RESOLUTION OF THE LOCAL PLANNING AGENCY OF
THE TOWN OF FORT MYERS BEACH, FLORIDA
RESOLUTION NUMBER 2000- 2

**FT. MYERS BEACH, FLORIDA
DEVELOPMENT SERVICES DIVISION
STAFF REPORT**

CASE NUMBER: 99-09-352.02Z 01.01

MASTER CONCEPT PLAN (CPD) FOR LIGHTHOUSE ISLAND RESORT

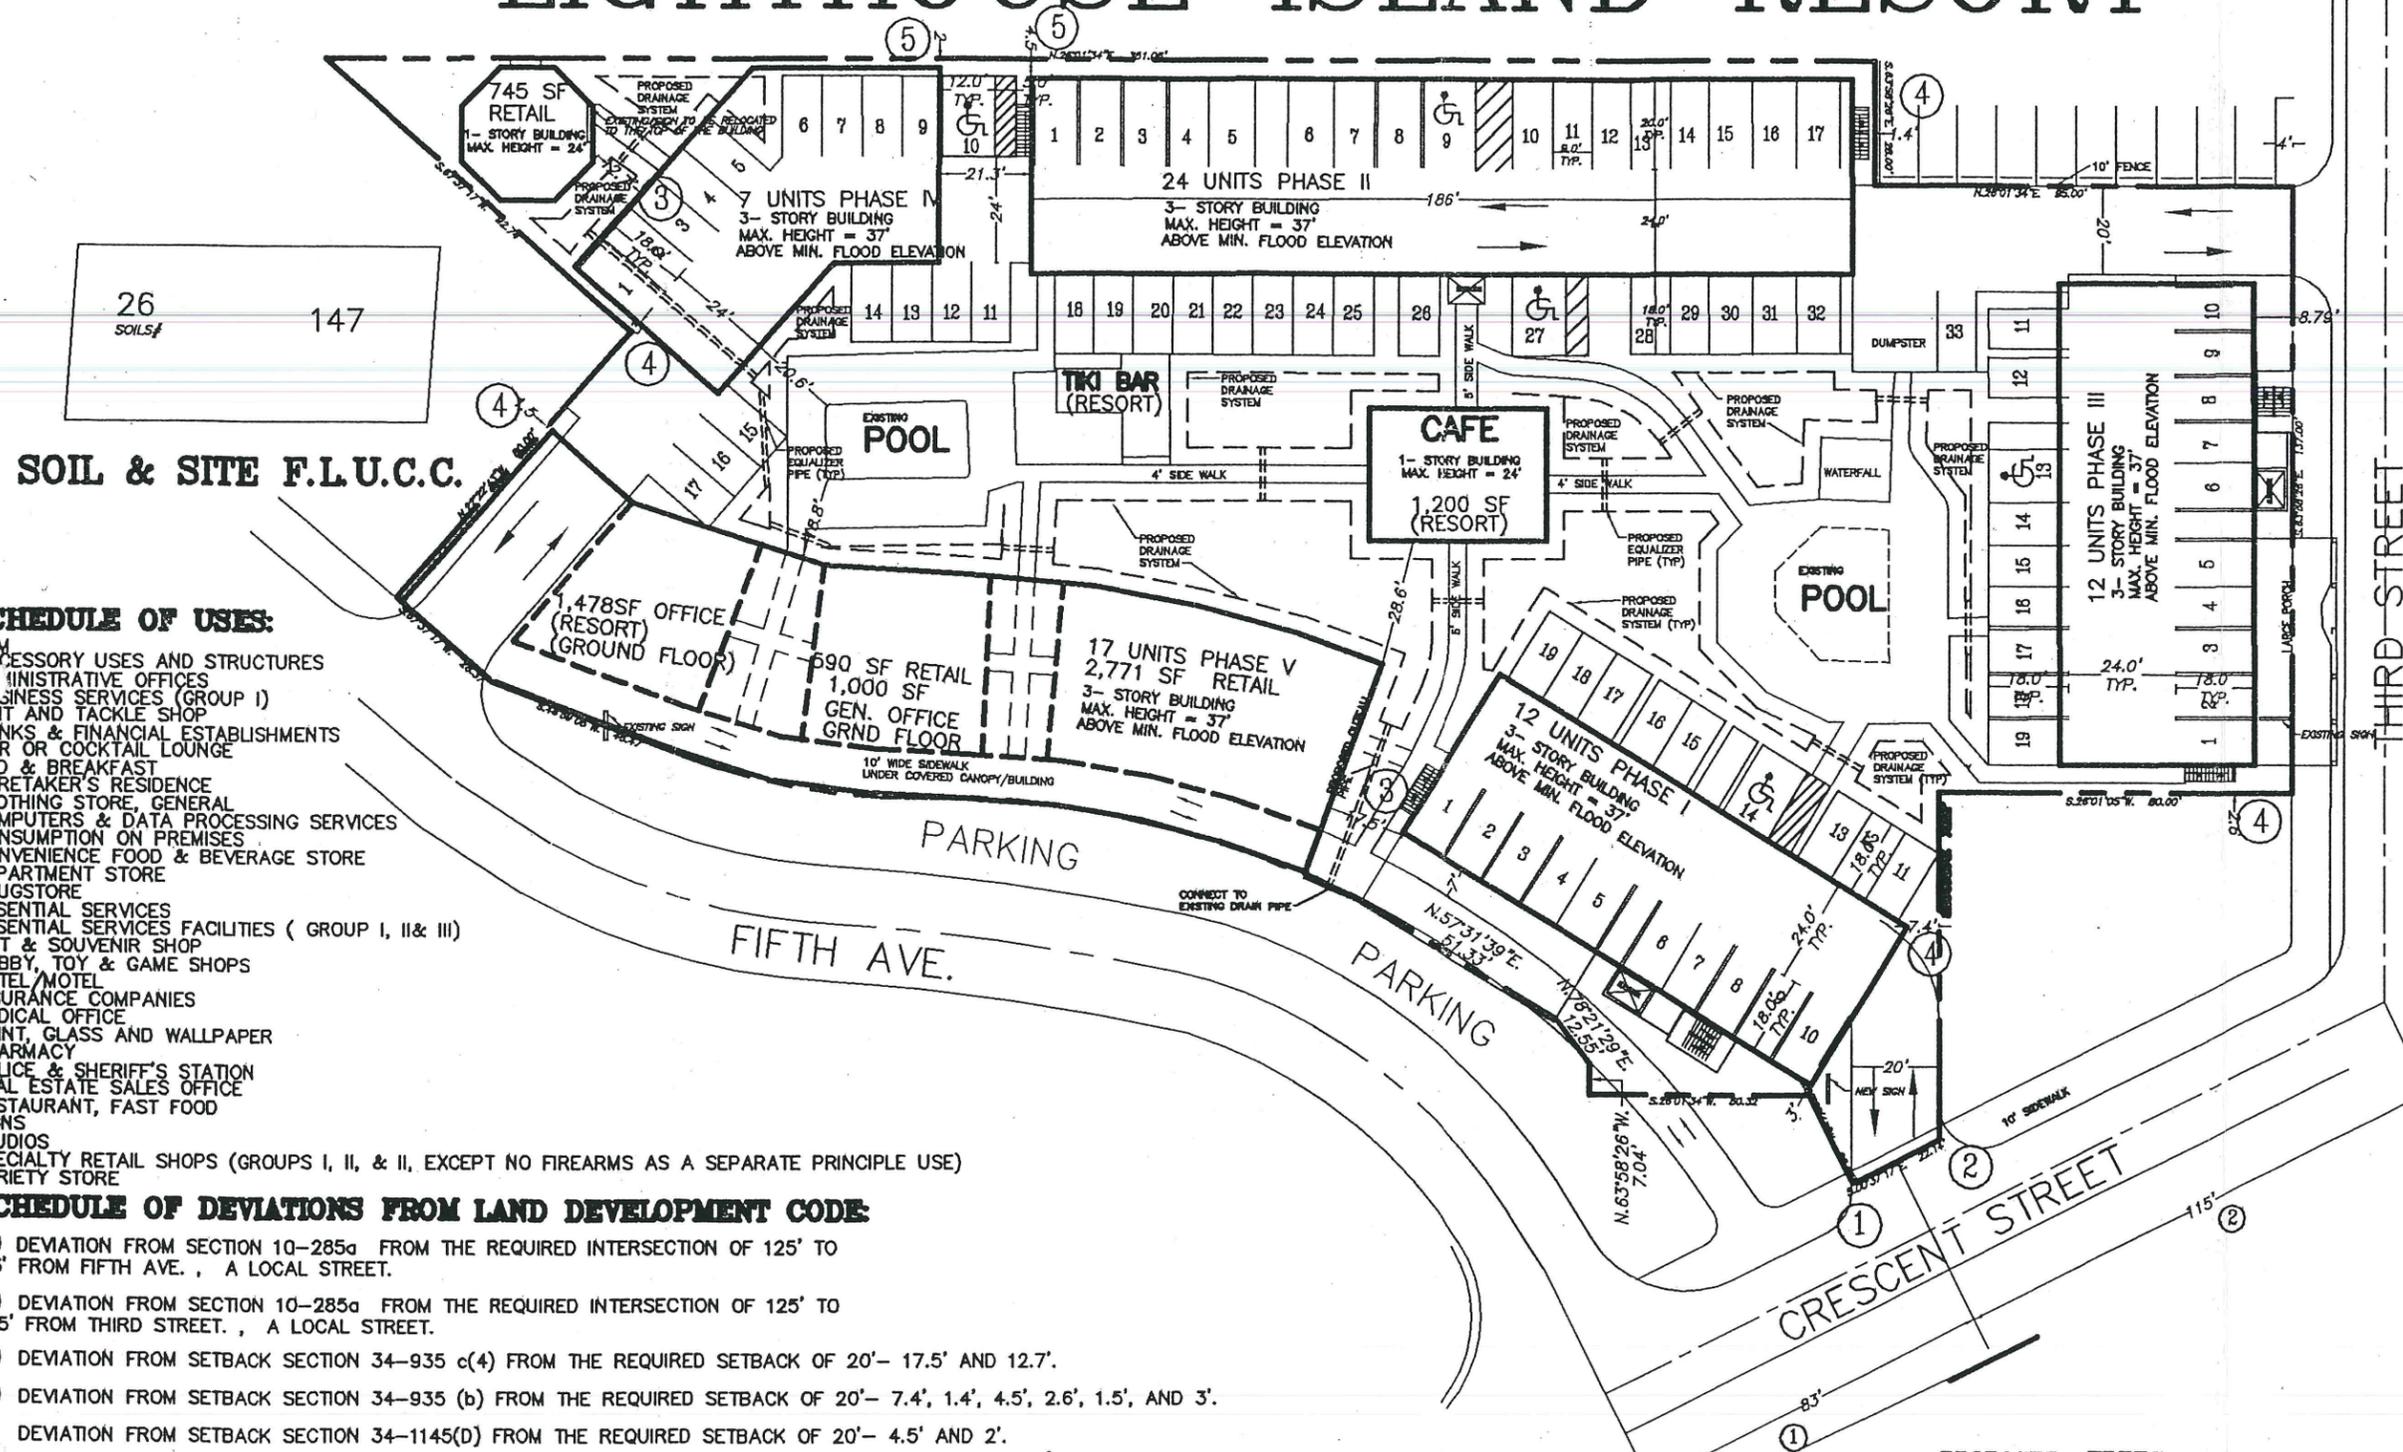
1. The development of this project must be consistent with the one-page Master Concept Plan (MCP) for "Lighthouse Island Resort," stamped received November 3, 1999, except as modified by the conditions below. This development must comply with all requirements of the Town of Fort Myers Beach LDC at time of local Development Order Approval, except as may be granted by deviation as part of this planned development. If changes to the Master Concept Plan are subsequently pursued, appropriate approvals will be necessary.

Deviation 1 requests relief from LDC Section 10-285(a) which requires a minimum connection separation of 125 feet along a local road (Crescent Street); to allow a connection separation of 83 feet from Fifth Avenue. This deviation is recommended to be **APPROVED**.

Deviation 2 requests relief from LDC Section 10-285(a) which requires a minimum connection separation of 125 feet along a local road (Crescent Street); to allow a connection separation of 115 feet from Third Street. This deviation is recommended to be **APPROVED**.

Deviation 3 requests relief from LDC Section 34-935(c)(4) which requires a minimum building separation of one-half the sum of the height of the structures, or 20 feet, whichever is greater; to allow building separations of 17.5 (between Phase I and Phase V) and 12.7 feet (between Phase IV and the adjoining retail building). This deviation is recommended to be **APPROVED as depicted on the approved Master Concept Plan**.

Deviation 4 requests relief from LDC Section 34-935(b) which requires certain setbacks for structures, buildings, and pavement from the development perimeters; to allow the reduced setbacks from the development perimeter as depicted on the Master Concept Plan. This deviation is recommended to be **APPROVED**.

Deviation 5 requests relief from LDC Section 34-1145(d) which provides the property development regulations for the Fort Myers Beach Downtown District; to allow setbacks of 2.0 and 4.5 feet along San Carlos Boulevard.. This deviation is recommended to be **APPROVED**.

Deviations 1 and 2 seek approval of a reduction in the connection separation requirement to allow a driveway connection to Fifth Avenue across from the existing Helmerich Plaza driveway access. Staff finds that it is appropriate to locate the access point at this location to reduce the potential negative impacts of having offset connections too close together and adversely impacting the traveling public. Approval of this also ultimately reduces the overall impacts if the project is approved. The current project has many parking spaces which directly enter and exit from the adjoining road rights-of-way creating potential traffic problems and increasing the potential for accidents. Staff recommends approval of these deviations.

Deviation 3 seeks to be allowed to have adjoining buildings within the project closer than the required 20 feet. Because of the unusual shape of the site and the applicant's desire to redevelop the site in conformance with the Town's desire for development in the Pedestrian Commercial category, it is found that in two places the buildings cannot meet the required 20 foot separation and requests a reduction to 7.5 feet and 12.7 feet. Construction of the buildings will still have to comply with all other development standards including the building and fire codes. Sufficient safeguards for the public staying on-site are found in these rules to maintain the public's health and safety. Staff recommends approval of this request.

Deviations 4 and 5 seek reductions in the building setbacks from the perimeter of the site. These setbacks are being requested to comply with the Old San Carlos Boulevard/Crescent Street Master Plan where buildings are expected to be built to the perimeter of the site. Although requested, Deviation 5 may not be needed. However, to ensure that the intent of
